East West Link (Eastern Section) Project

Assessment Committee Report

30 May 2014

Figure 13: Sheet 13 from CIS Mapbook

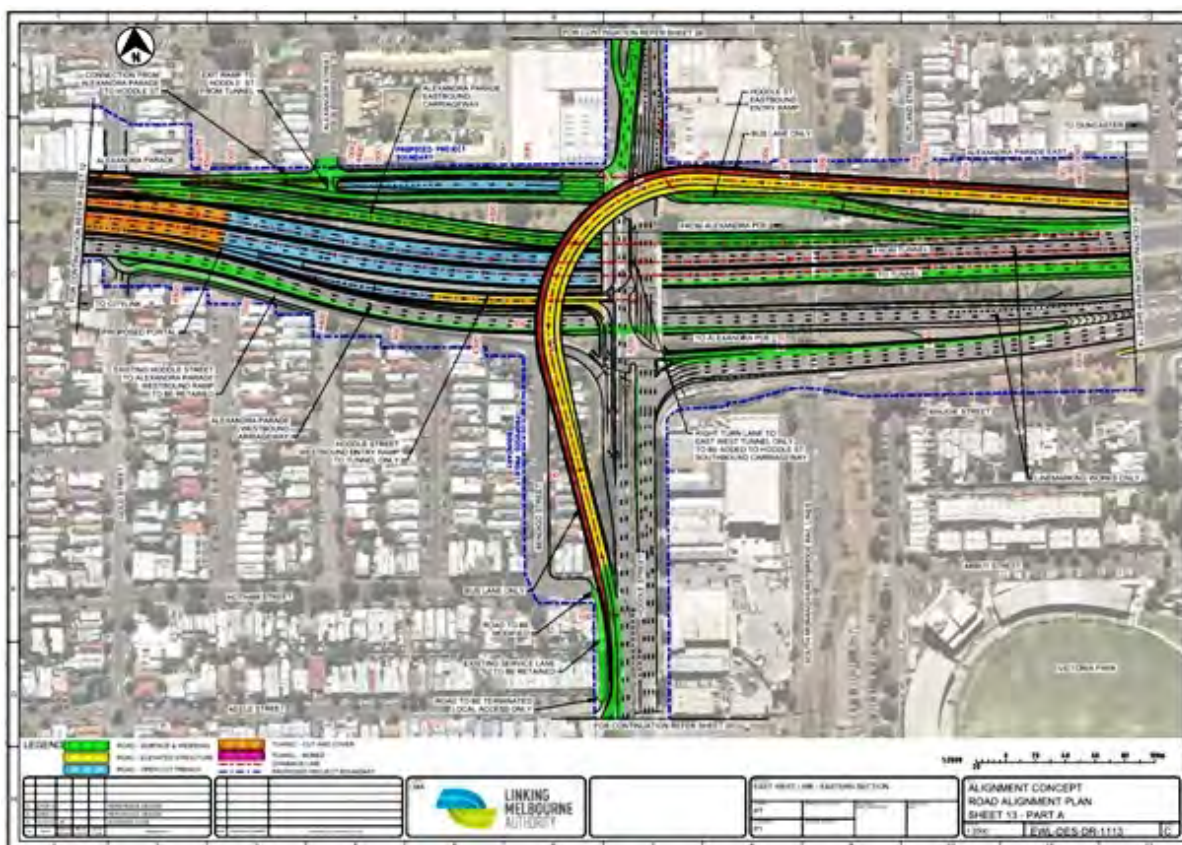
6. **Prohibit road construction at grade beyond the northern road reservation boundary on Alexandra Parade between Smith Street and Gold Street, and delete that area from the Proposed Project Boundary. Sequence the construction process and the management of traffic on Alexandra Parade during construction so that all ground level activity occurs within the Alexandra Parade road reserve, thereby negating the need for the sidetrack and the proposed property acquisition for it.**

Figure 15: Sheet 6 from CIS Mapbook

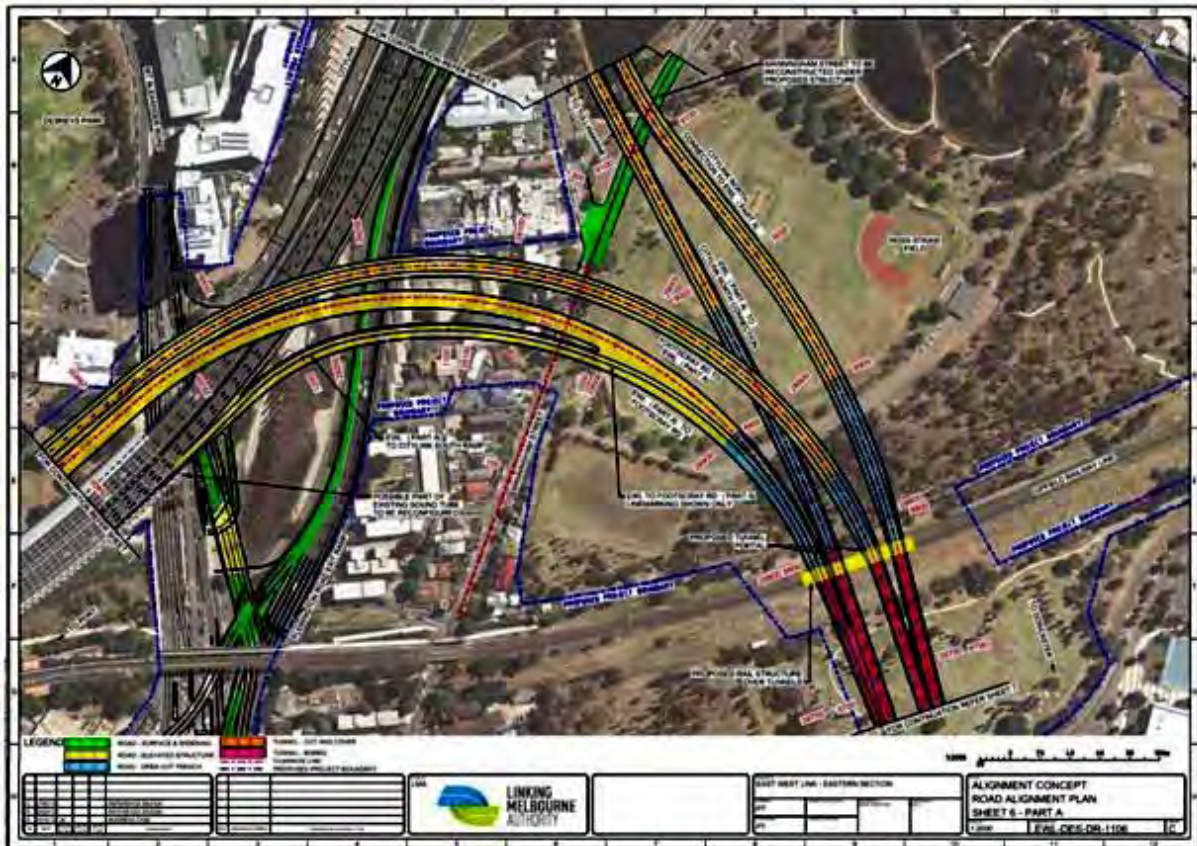
If it is determined that the Ormond Road off ramp is to be retained, Mr O'Brien has suggested an alternative design to that shown on the Reference Project. The Project (Part A) to CityLink, north connection shown on Mapbook Sheet 5 is to be re-aligned to join the northbound carriageway of CityLink approximately 1300 metres south of the Reference Project connection. The Ormond Road off ramp is then re-aligned to provide greater clearance to the Essendon Community Garden. Minimal construction works are required under the Ormond Road bridge. The design modifications suggested by Mr O'Brien reduce the impact upon Holbrook Reserve and Ormond Park.

The location of the Ormond Road exit ramp is dictated in part by the design of the Project and CityLink North Connection, as shown on Sheet 6, in the Mapbook. However, as Mr O’Brien has shown, other options are available which would reduce the impact of the ramp on the Essendon Community Garden and Brisbane Street. The other benefit to be derived from modifying the ramp design as per the O’Brien proposal is the reduced impact upon Council Reserves.

10. **Revise the ramp connections between the western portal and CityLink North as shown on the Reference Project, and investigate alternative alignments further to the north-east.**
